SUNSHINE COAST REGIONAL DISTRICT

Question and Answers #2

Request for Proposal No. 2437001

Engineering Services for Cove Cay Pump Station and Treatment System Upgrade

Item No.14

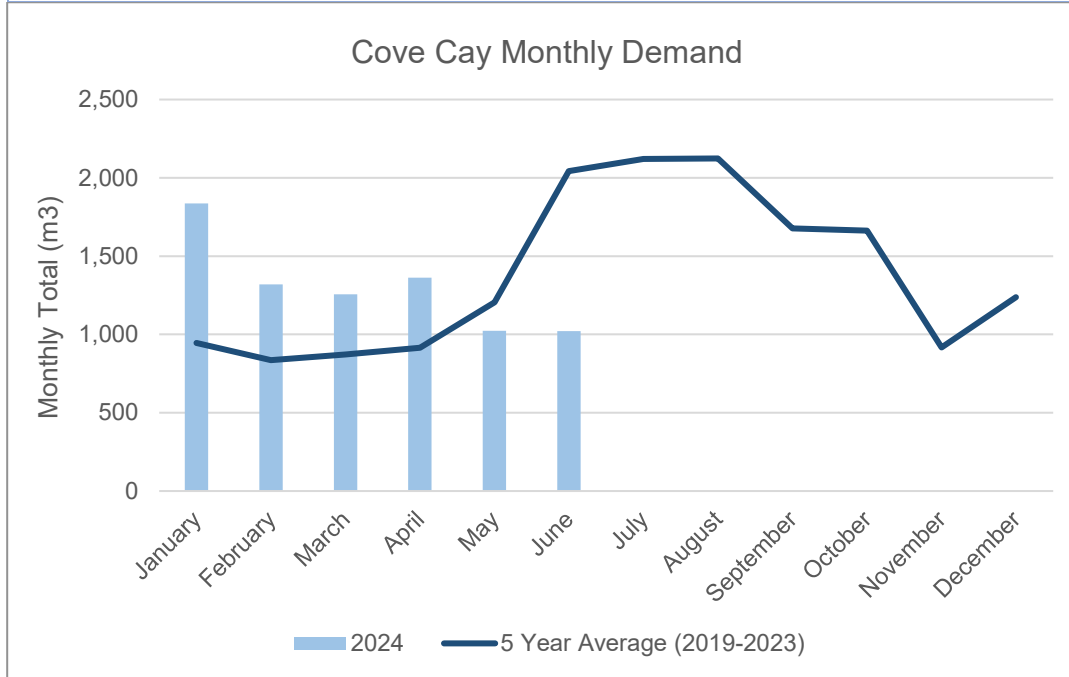
Question: What is the average daily flow of water, and do you have any records?

Answer:

Month	5 Year Average (2019-2023)		2024
January	945		1,836
February	836		1,320
March	872		1,257
April	916		1,363
May	1,206		1,024
June	2,043		1,021
July	2,121		
August	2,124		
September	1,677		
October	1,662		
November	916		
December	1,237
